**Application No: 3317/24**

**Proposal: LAW:PROTECTED STRUCTURE:**

**Location:** Newcomen Bank, 16, Castle Street, Dublin 2

**PLANNER'S REPORT**  
**LAW 3317/24**

Drawing No.	Revision
L-021	-

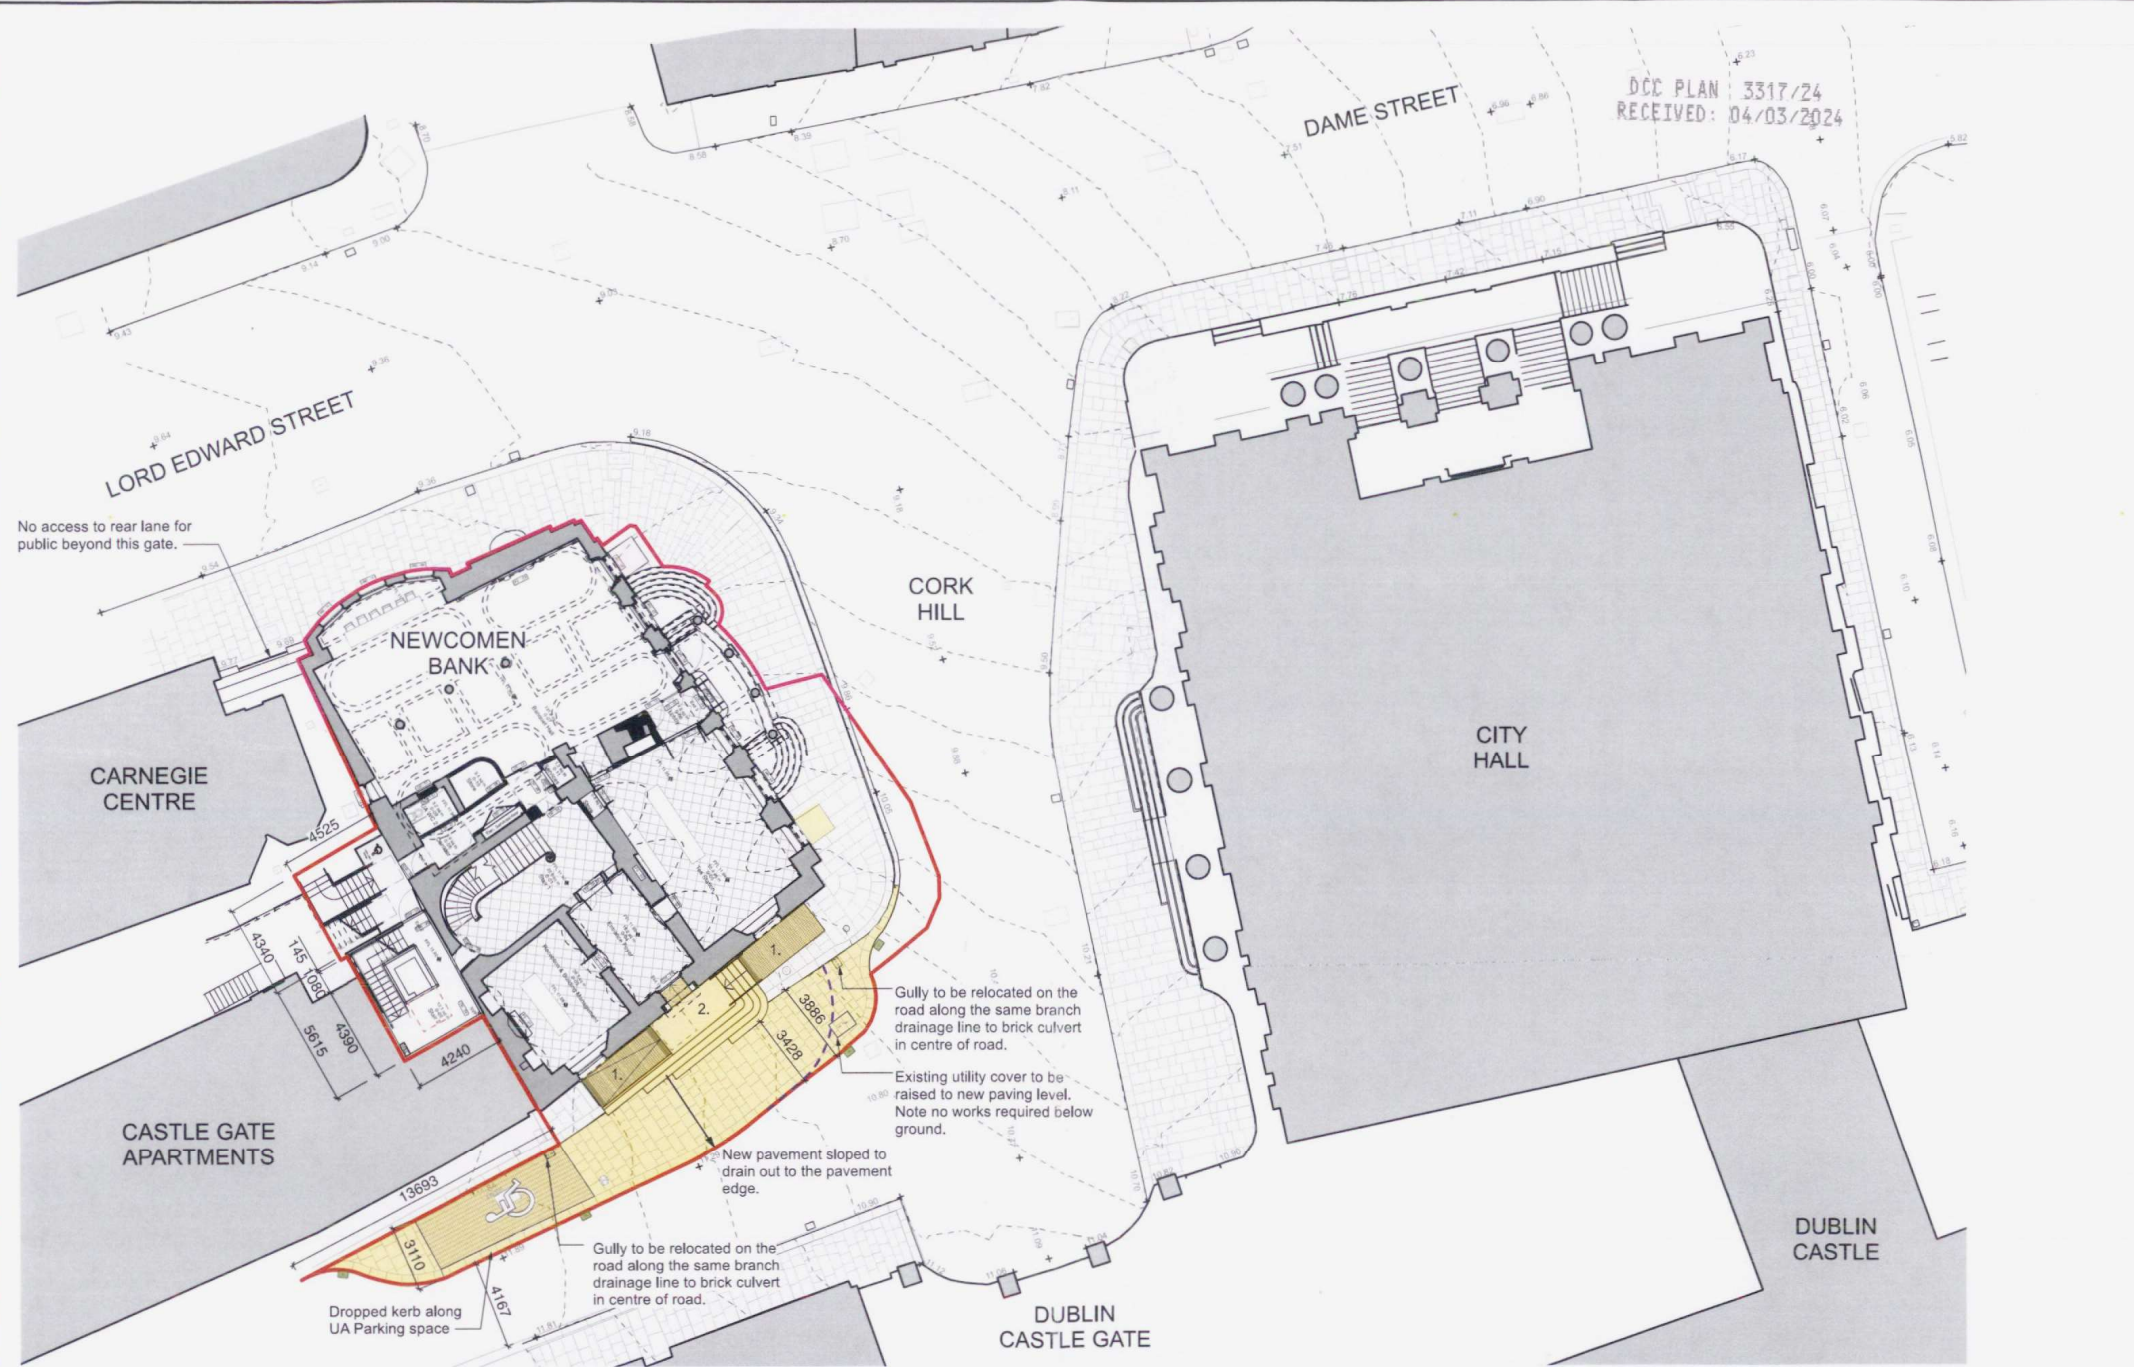
The submission of drawing nos. L-101 and L-315 is acknowledged which indicate the extent of granite that will be removed to accommodate the new pavement lights. It is clear from the drawing that a number of slabs will have to be lifted and cut prior to their reinstatement. Whereas the cutting of historic paving stones should be avoided if possible, where this is unavoidable, sharp (cut) edges of stones (where cutting is necessary) to be reinstated shall be tooled by specialist stonemasons to match the edges of existing historic paving. The removed historic paving shall be assessed, quantified, recorded on a detailed schedule so that a suitable reuse can be determined.

It is understood that there is sufficient space for a wheelchair to turn at the top of the new sloped entrance, and the turning 'square' of 1500mm at the front entrance door is Part M Compliant for existing buildings, and a full DAC will be submitted for this Protected Structure.

*Detailed drawings shall be submitted of proposed ventilation grilles within the new pavement lights in advance of the works commencing.*

*The existing coal hole shall be retained in situ below the new steps to the building.*
